AMENDMENT OF SOLICITATION

1. AMENDMENT/MODIFICATION NO. 0002		2. EFFECTIVE DATE AUG 23, 2003	
3. ISSUED BY DEPARTMENT OF THE ARMY, BALTIMORE DISTRICT CORPS OF ENGINEERS P.O. BOX 1715 BALTIMORE, MARYLAND 21203-1715 CODE: _____

6. ACCOUNTING AND APPROPRIATION DATA (If required) GATED SPILLWAY ELECTRICAL AND CONTROL UPGRADE, RAYSTOWN LAKE, PA			
7. DESCRIPTION OF AMENDMENT/MODIFICATION (Organized by UCF section headings, including solicitation/contract subject matter where feasible.) <u>SPECIFICATIONS:</u> (1) Section 11287 Page 2, Paragraph 2.1: Make the following changes: (a) In the first sentence change the wording "Electrical equipment, motors, motor efficiencies, and wiring..." to read "Electrical equipment and wiring...". (b) In the second sentence change the wording "Motors shall be of the high efficiency type and..." to read "Motors shall be of the design "C" type, with 225% locked rotor torque as a percentage of full load torque and...". <u>DRAWINGS:</u> (2) <u>Plate 6:</u> Add humidity sensor next to the thermostat adjacent to dehumidifier, in accordance with sketch SK-1, dated August 17, 2004. Except as provided herein, all terms and conditions of the document referenced

SK-2

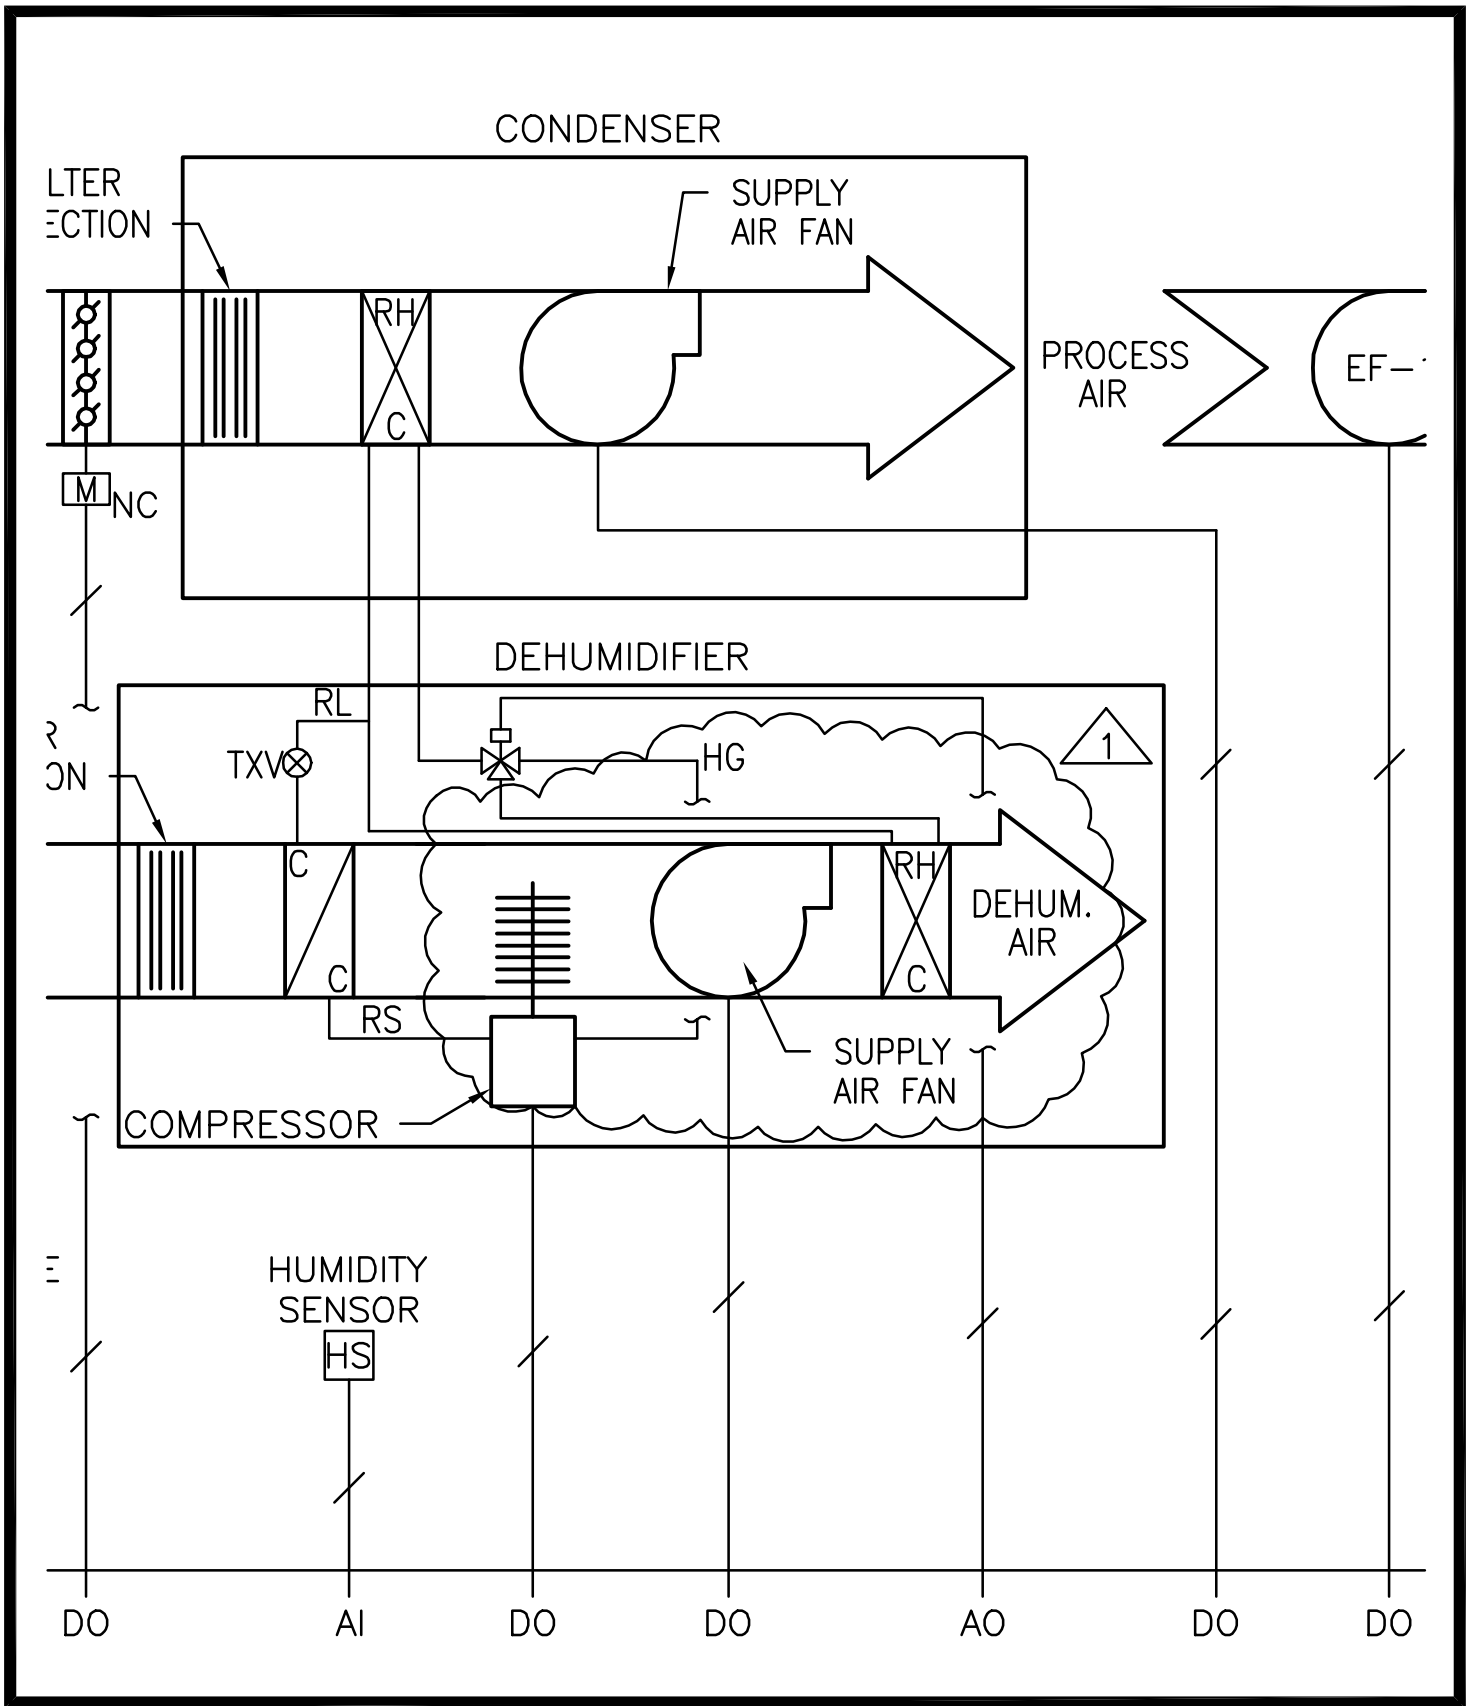
(3) Plate 7: Relocate reheat coil in dehumidifier unit upstream of the fan, in accordance with sketch SK-2, dated August 17, 2004. Note that any arrangement of a packaged factory fabricated dehumidifier that meets the scheduled performance criteria will be acceptable.
